SERVICE LETTER

No. 532

Piper Aircraft Corporation

Subject: Voltage Regulation Component Grounding

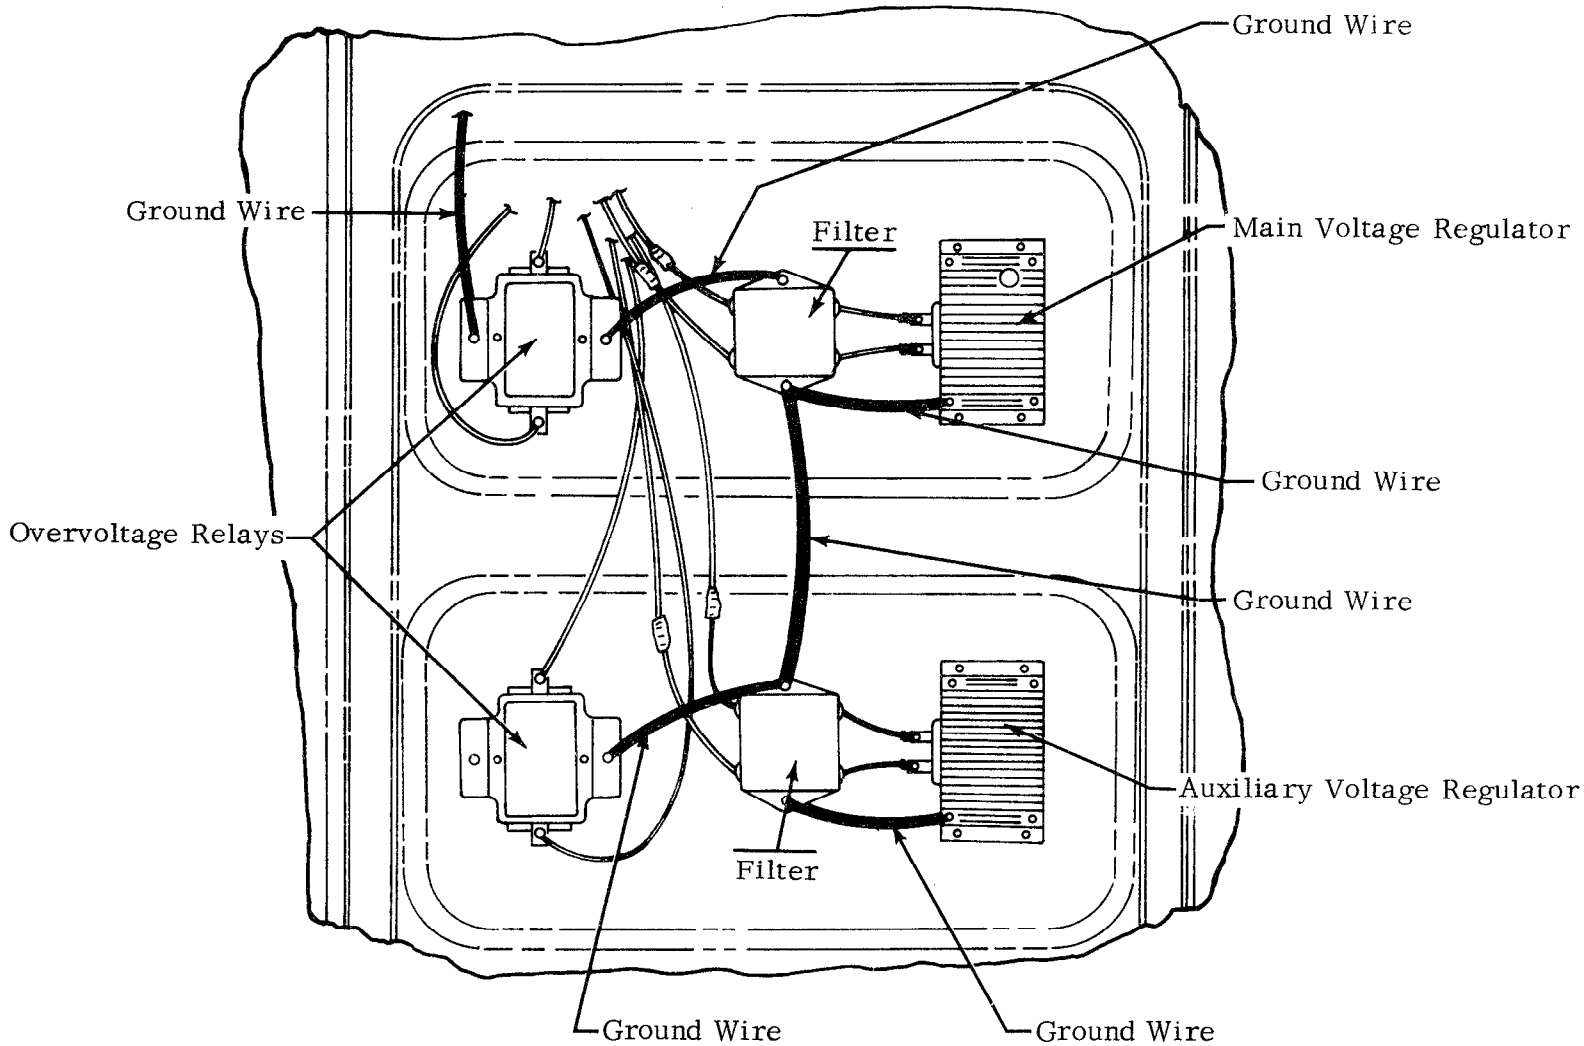
Purpose: To provide a supplemental method of grounding the aircraft voltage regulation system components to the aircraft structure. See sketch attached to this letter for general information.

This Sketch represents the Aztec "D" Voltage Regulation Component Grounding Modification, and is similar to the modification required for affected PA-30 and PA-31 aircraft.

Instructions: Contained in Kits No. 760 331 (PA-23-250 six place Aztec "D"), 760 332 (PA-30 Twin Comanche "C") and 760 333 (PA-31 and PA-31-300 Navajo) Voltage Regulation Component Grounding Installation

Detailed Sketches relative to the above referenced aircraft are contained in the applicable Voltage Regulation Component Installation Kits, specified on the Service Letter.
